# RS-FEC EEE Fast Lock Using Rapid Codeword Markers

IEEE P802.3by 25Gb/s Ethernet Task Force Ad Hoc

May 2015

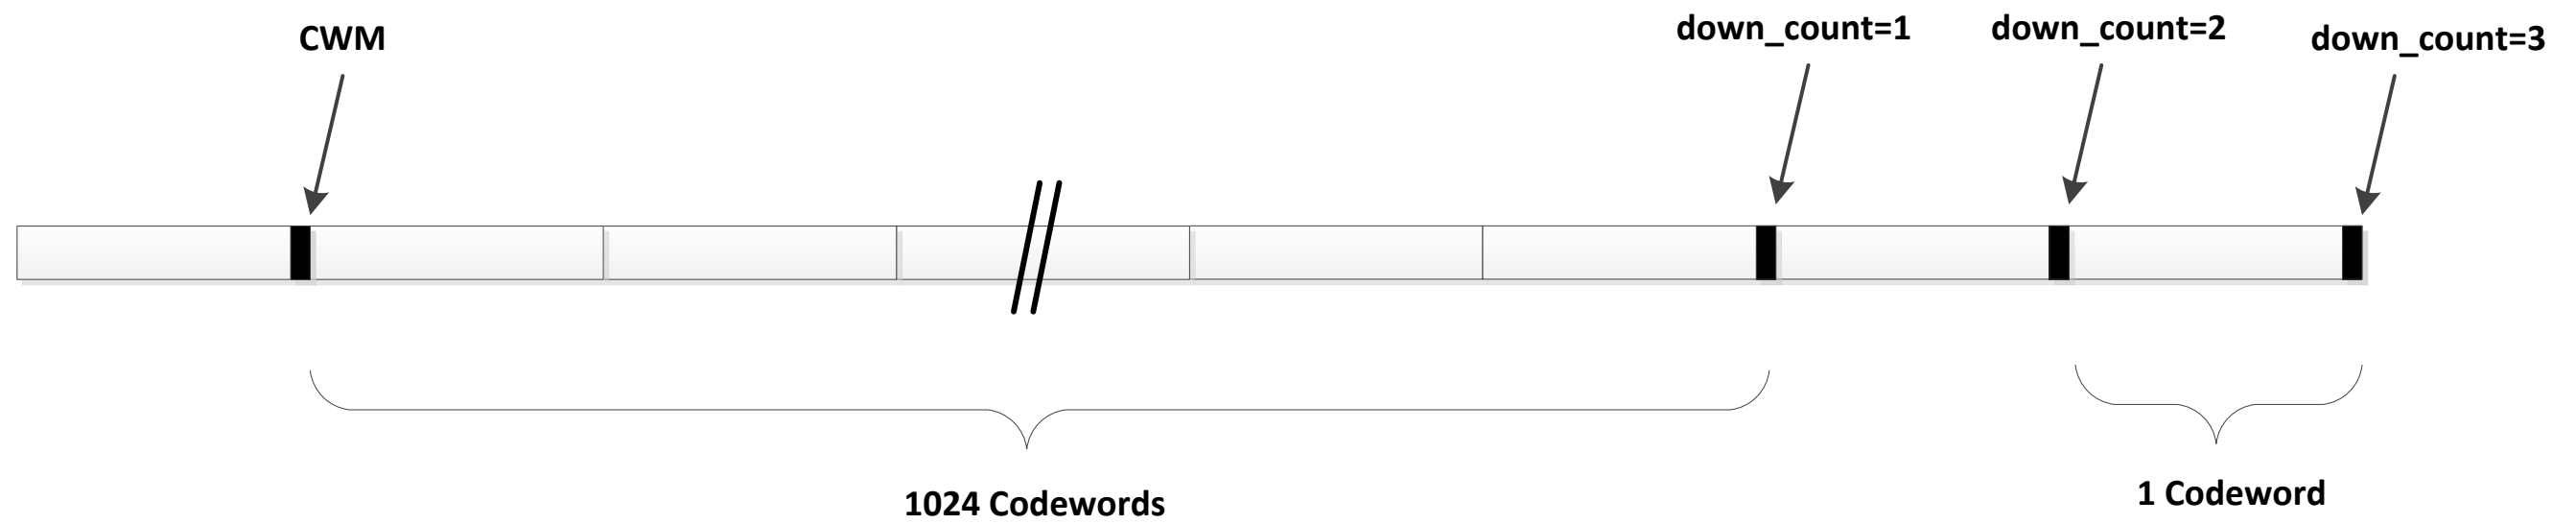
- Unscrambled IDLEs/LPIs are not DC balanced and don't have enough transition density, which is unsuitable for the electrical signaling.
  - See ran\_042915\_25GE\_adhoc and #38,#179
- Sending unscrambled IDLEs/LPIs enables the peer port to detect transcoding block boundaries. However it does not provide an efficient way to detect the FEC codeword boundaries.
  - Comment #179
- Sending unscrambled data at the start of TX\_WAKE (TX\_MODE transition from ALERT to DATA), does not allow the peer PMA/PMD to refresh. As a result the peer RS-FEC may not detect the pattern and lock.
  - Comment #75
